From: Schultz, Josie M - DNR
Sent: Thursday, August 13, 2020 12:46 PM
To: 'Donald P. Gallo'
Cc: 'Matt Dahlem'; 'Silje Roalsvik'; Nancy Reid
Subject: RE: Revised Sampling Plan - Bay Towel

Thank you for your email regarding Bay Towel – Solvent Investigation, BRRS # 02-05-237064. The DNR cannot provide a specific concentration for saturated soil clean-up goal/mass removal at this time as DNR soil standards apply to unsaturated soil and present soil contamination is at depths below the historic low groundwater table. Although this soil is saturated, additional mass removal would likely reduce the receptor risk, length of long-term monitoring, and bring this site to closure in a shorter timeframe. The cleanup goal is based on the factors of closure; ensuring that the site investigation (SI) is complete, groundwater plume is stable, utilities aren't acting as a preferential pathway, and vapor intrusion issues are addressed both off-site and future on-site.

FIGURE 1
 PROPOSED ADDITIONAL SAMPLES
 BAY TOWEL – SOLVENT INGESTION
 501 S. ADAMS ST.
 GREEN BAY, WI 54301
 BRRTS NO.: 02-50-237064

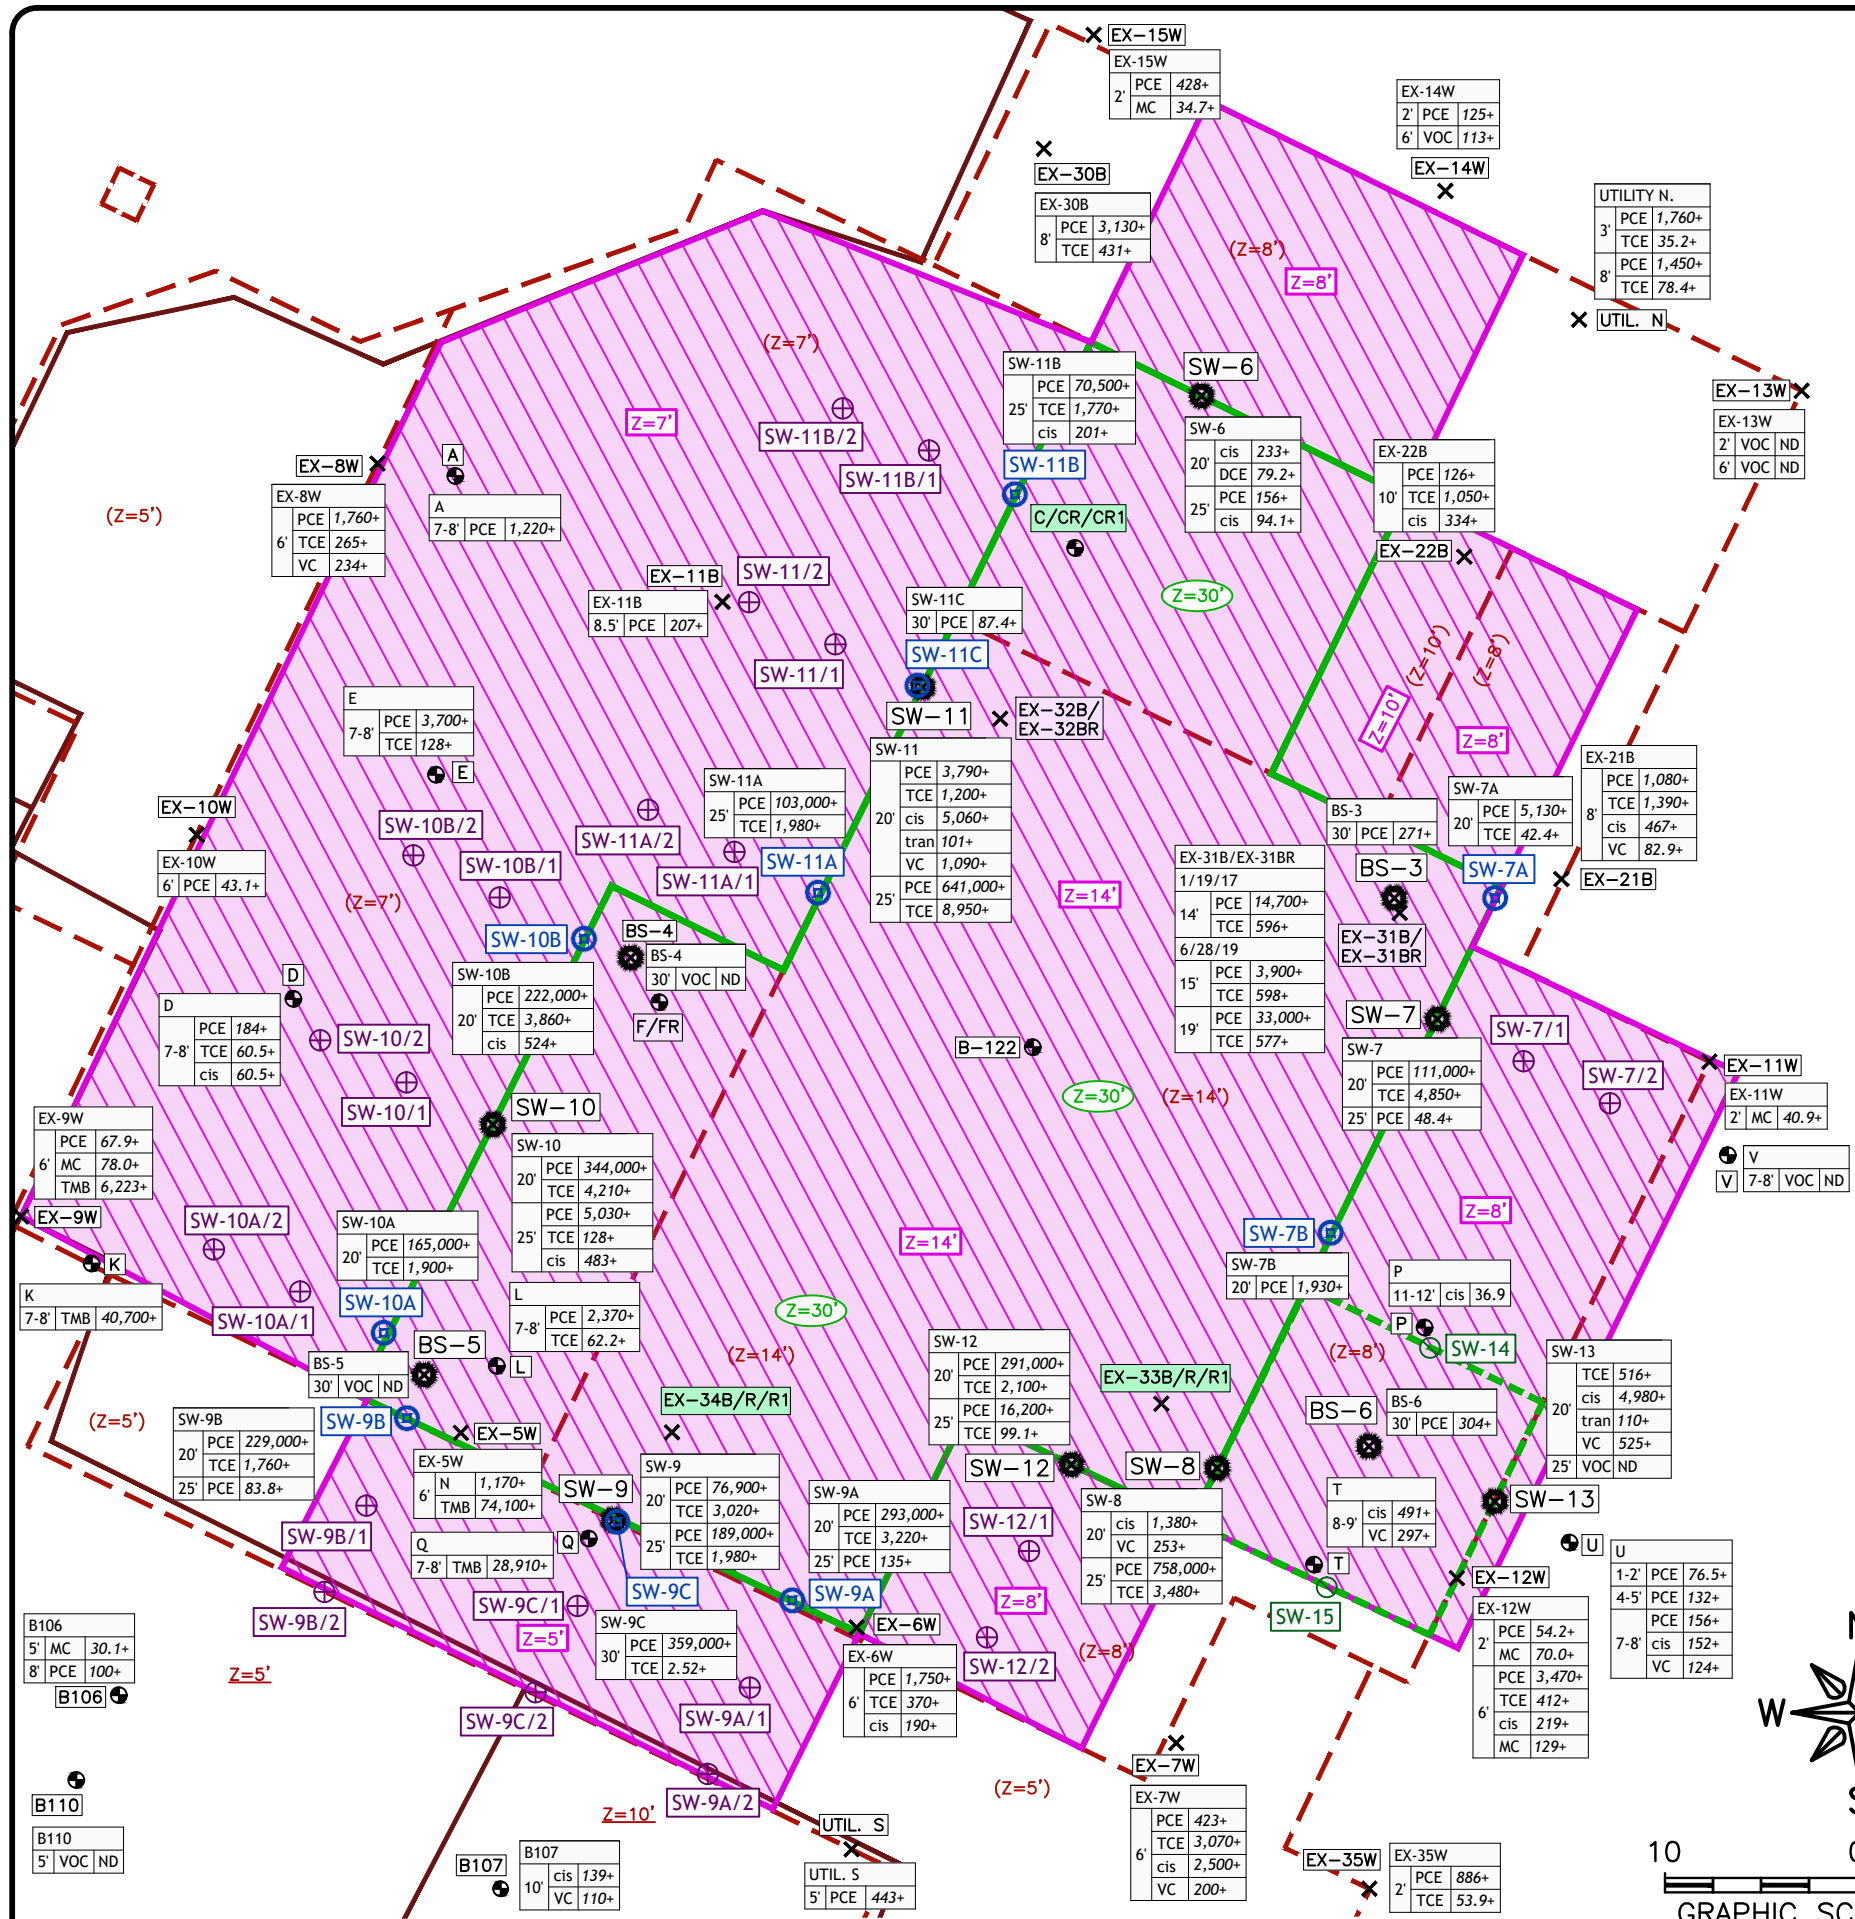
So we have stepout borings at the sidewall samples that exceeded our 33,000 ug/kg threshold at the following locations:

SW-7
SW-9A
SW-9B
SW-9 / SW-9C – same location
SW-10
SW-10A
SW-10B
SW-11
SW-11A
SW-11B
SW-12

Additionally, within the SW-8 excavation, soil was hottest at SW-8 at 25-feet. We got SW-13 delineated to the east and base sample BS-6 delineated vertically at 30-feet, but it appears there was no sampling done within the excavation to the north or south – so I added on SW-14 and SW-15 at 25-feet to delineate that small SW-8 excavation. It should be noted we cant take those personally as they are too deep – so we would need to probably sample those during additional excavations or we drill – we can discuss which option we choose. I just don't want us in the hole at that depth. We have data at "T" and "P" but shallow, with the hot stuff at 25-feet, I think we need to address these sidewalls at SW-14 and SW-15 to satisfy delineation
